DEVIATION REQUEST AND DECISION FORM

PROJECT INFORMATION – NEW LOG ROAD DEVIATION REQUEST

Project Name : Ellicott Town Center Filing No. 1

HORZ. SCALE: 1"=5'
VERT. SCALE: AS SHOWN
SURVEYED: CHECKED:
CREATED: 5/5/05 LAST MODIFIED: 9/12/19
PROJECT NO: 090001 MODIFIED BY: BJJ
SHEET: TY1

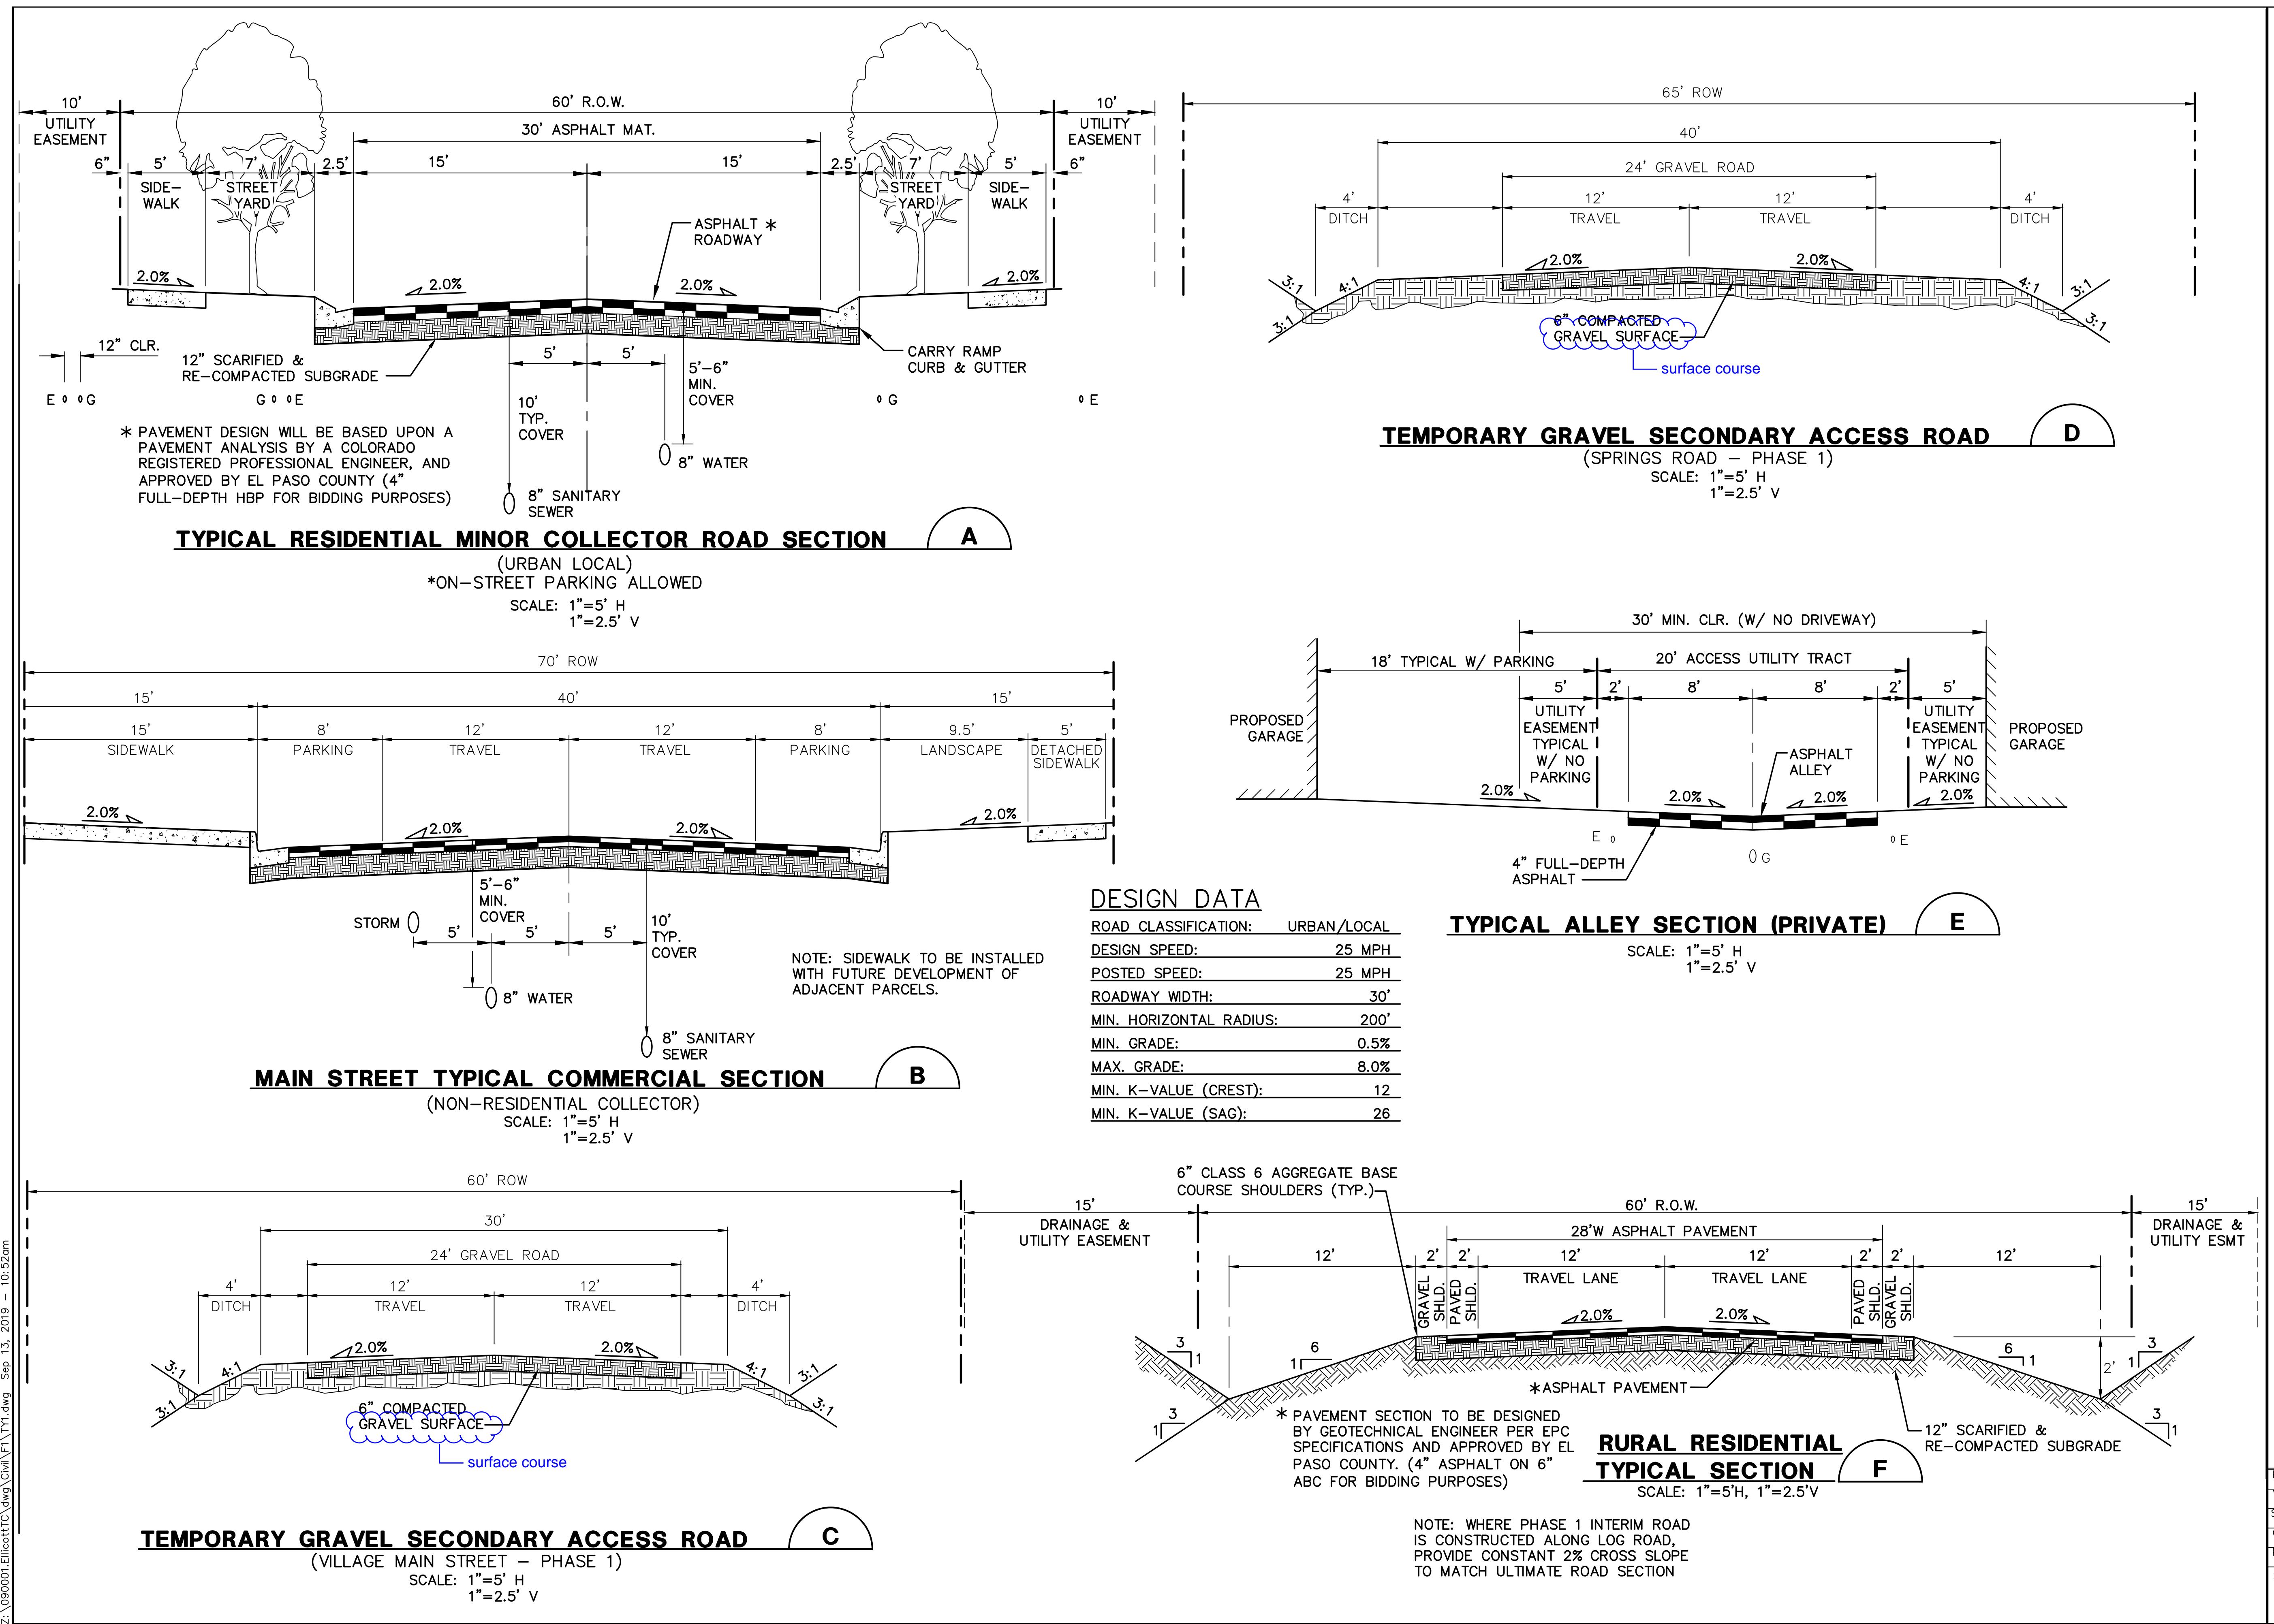
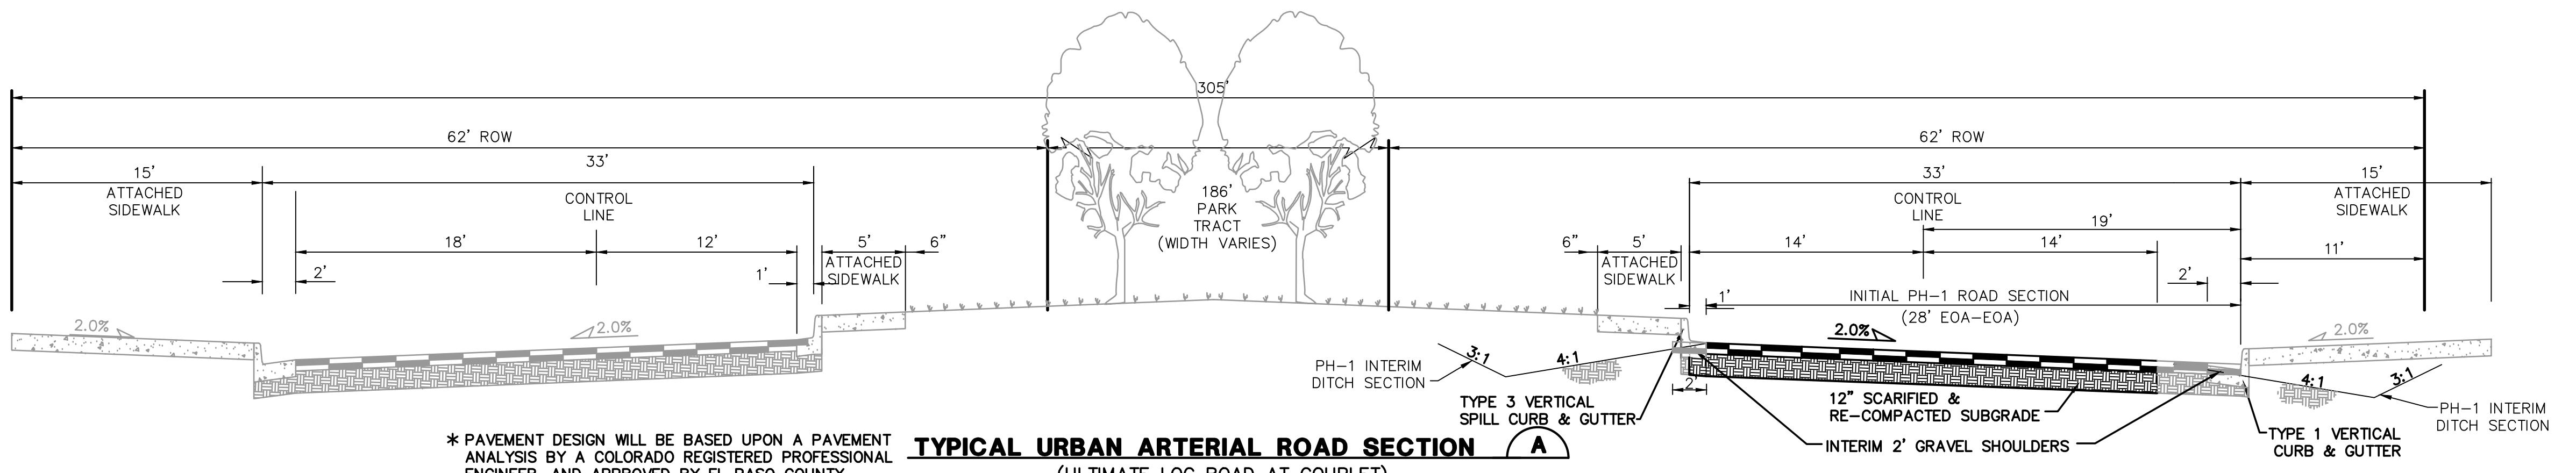
The interim road cross section consists of a 2-lane rural residential road section during Filing No. 1. The interim rural road section depicted on Section F, Sheet TY1 conforms to County standards for rural local roads.

HORZ. SCALE: 1"=5'	DRAWN: RMD
VERT. SCALE: AS SHOWN	DESIGNED: JPS
SURVEYED: 9/12/19	CHECKED: JPS
CREATED: 5/5/05	LAST MODIFIED: 9/12/19
PROJECT NO: 090001	MODIFIED BY: BJJ
SHEET: TY2

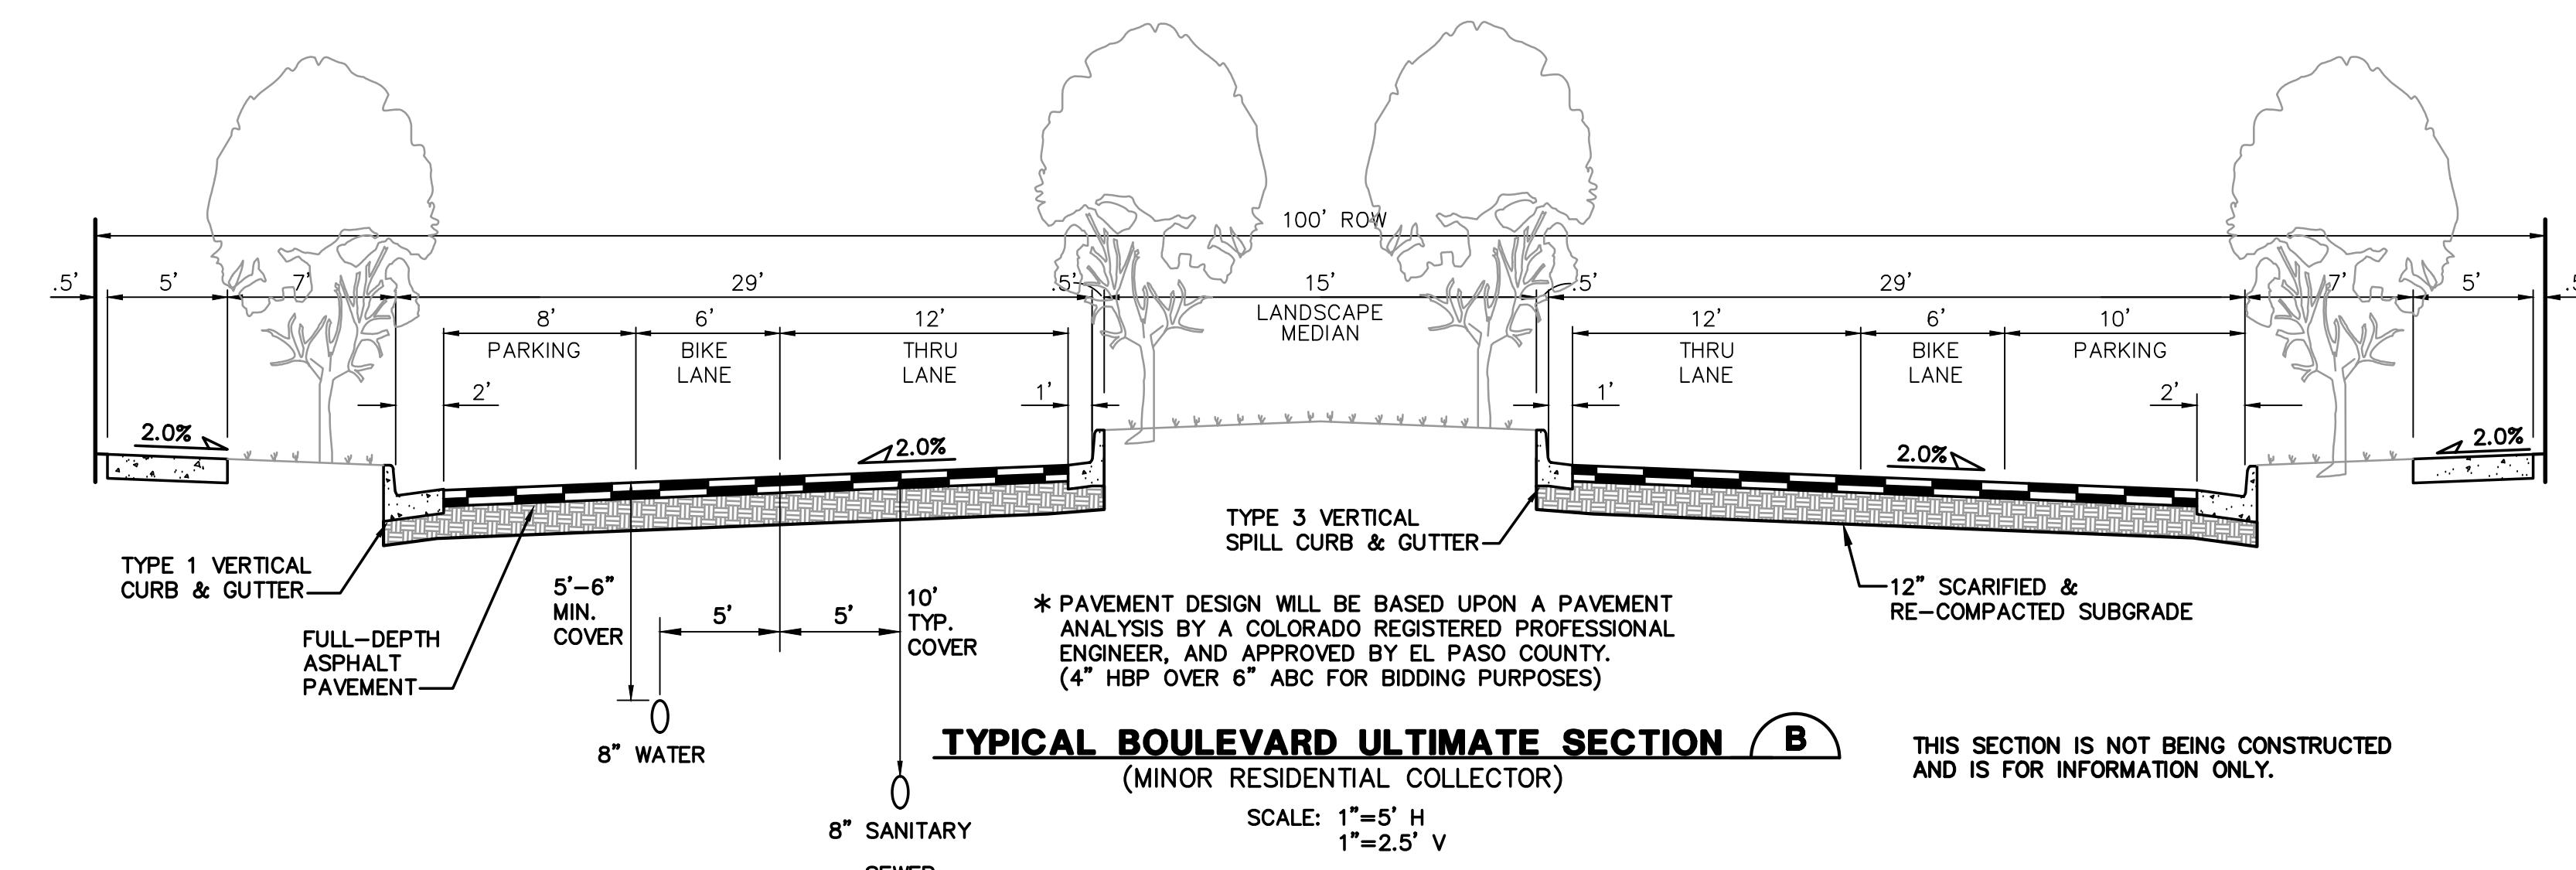
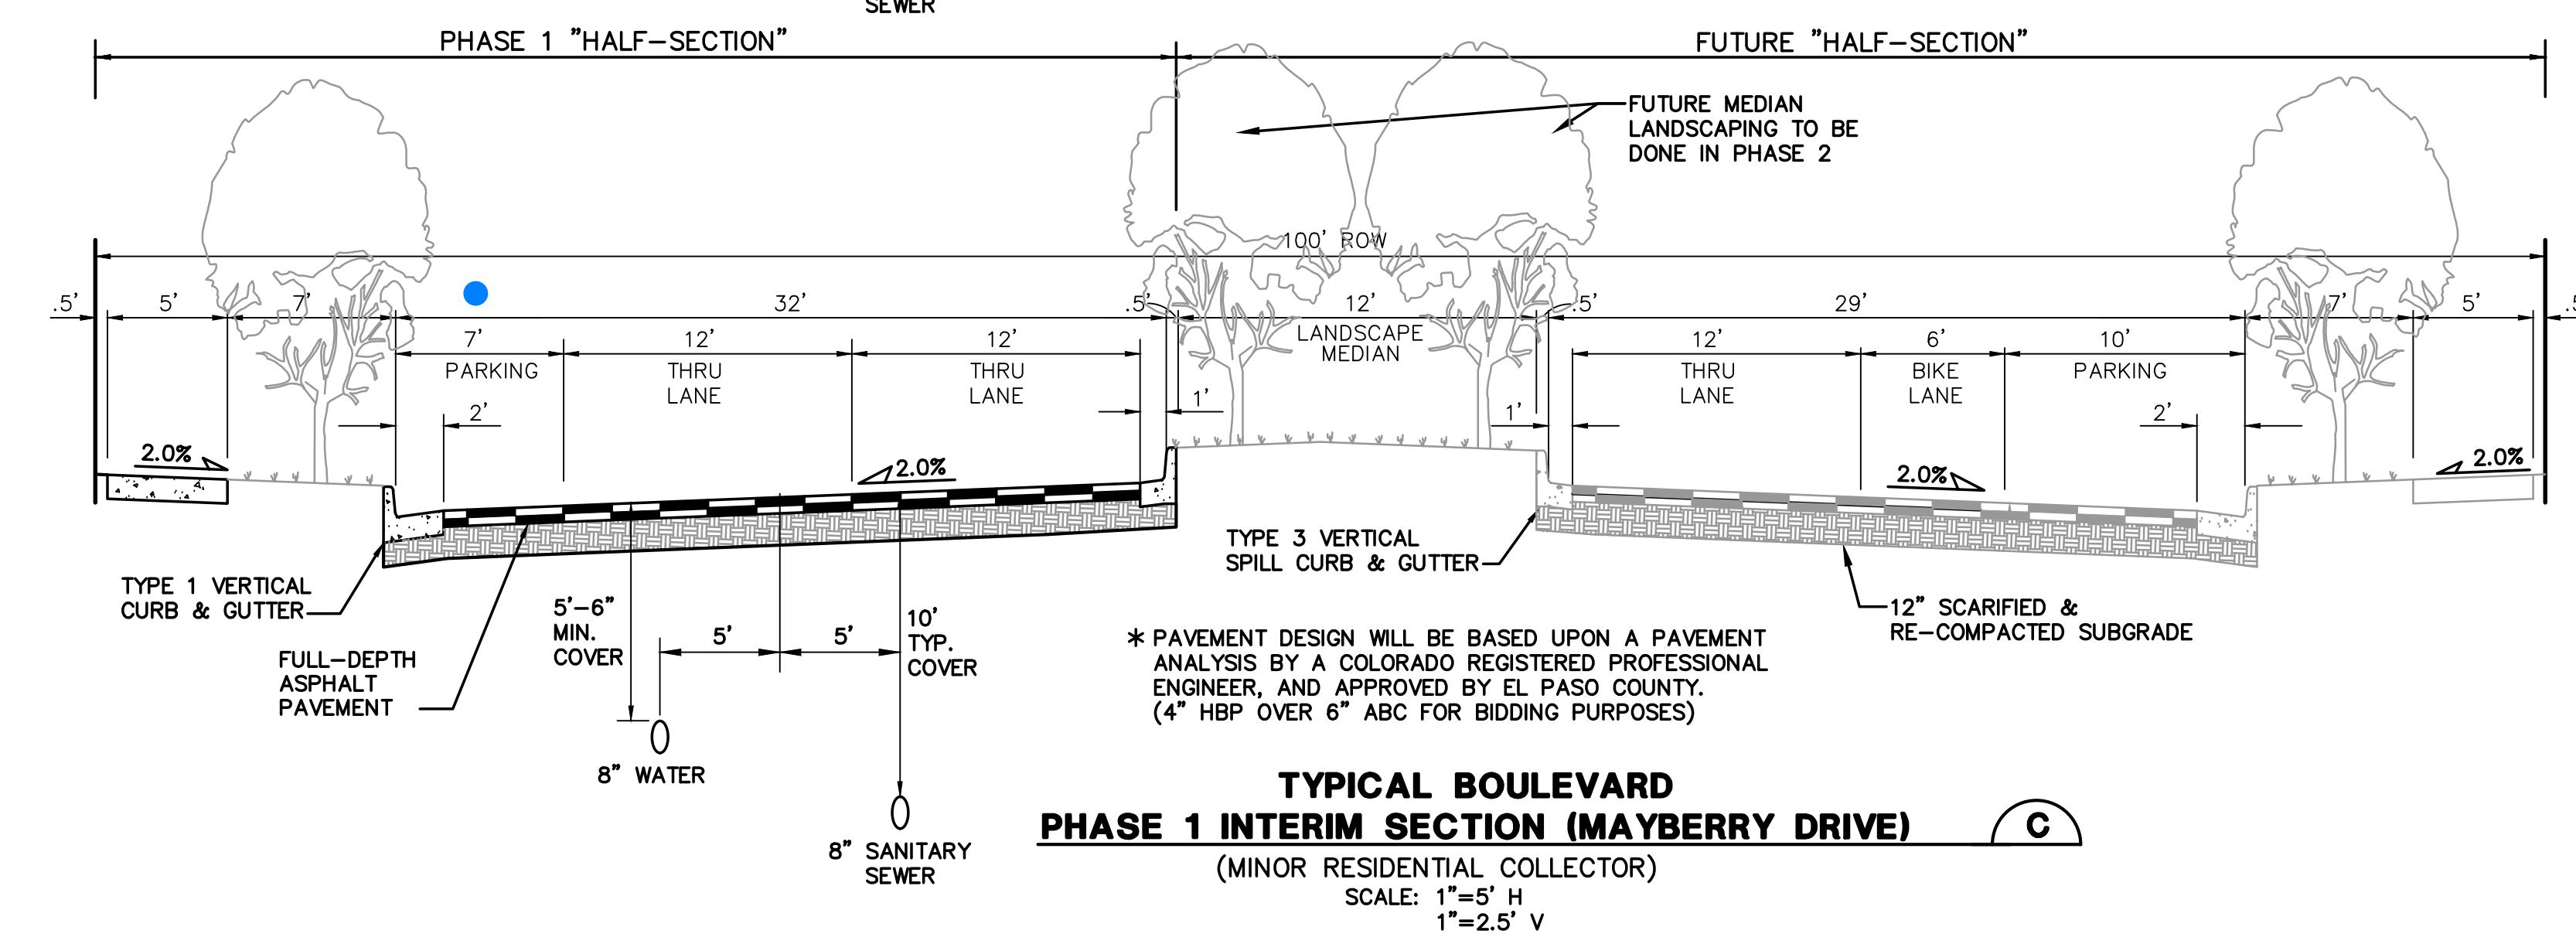
New Log Road is ultimately classified as an Urban Minor Arterial roadway. The proposed deviations consist of modified cross-section elements including 15-foot attached sidewalks, bike lanes permitted, and on-street parking allowed for the ultimate road section, as well as an interim rural asphalt road section during the initial phase of development. The proposed deviations are depicted on the Typical Road Section Drawings (Sh. TY1-TY2).

The ultimate road section of New Log Road consists of a 2-lane, 1-way Couplet through the Town Center area in accordance with the approved Ellicott Town Center PUD, as depicted in Section A, Sheet TY2.
